**Re: Cañon Dolomite Quarry, File No. M-1977-376,  
Preliminary Adequacy Review for Technical Revision No. 2 (TR-02) - REVISED**

The following comments are based on the Division's review of the Request for Technical Revision TR-02:

Diablo Canyon line

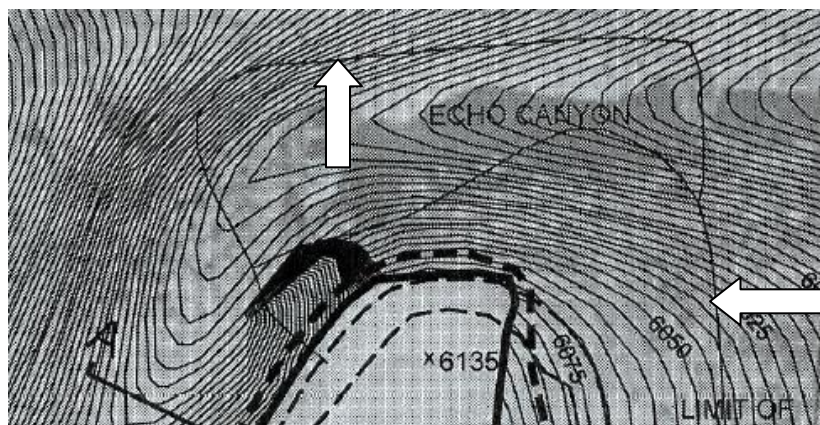
- c. Notes 3, 4 and 6 tally reclamation liability areas in the mine area (16.1 acres), “fill” area (2.2 acres) which do not match the mined area (36 acres) and affected area (55 acres) stated in Note 6. Further, the mine is permitted for 481 acres of disturbance.
  - i. Please explain the apparent discrepancy and provide a detailed tally for the purpose of estimating an appropriate financial warranty estimate
  - ii. Please clarify if “fill” in Note 4 should be “fines”.
- d. Note 8, Legal says Section 39, please correct the Section number.
- e. There are some fine lines on the drawing enclosing portions of Diablo Canyon and Echo Canyon, and a similar weight line connecting those enclosed areas running along the east side of the mine area (see below). Please identify these lines.
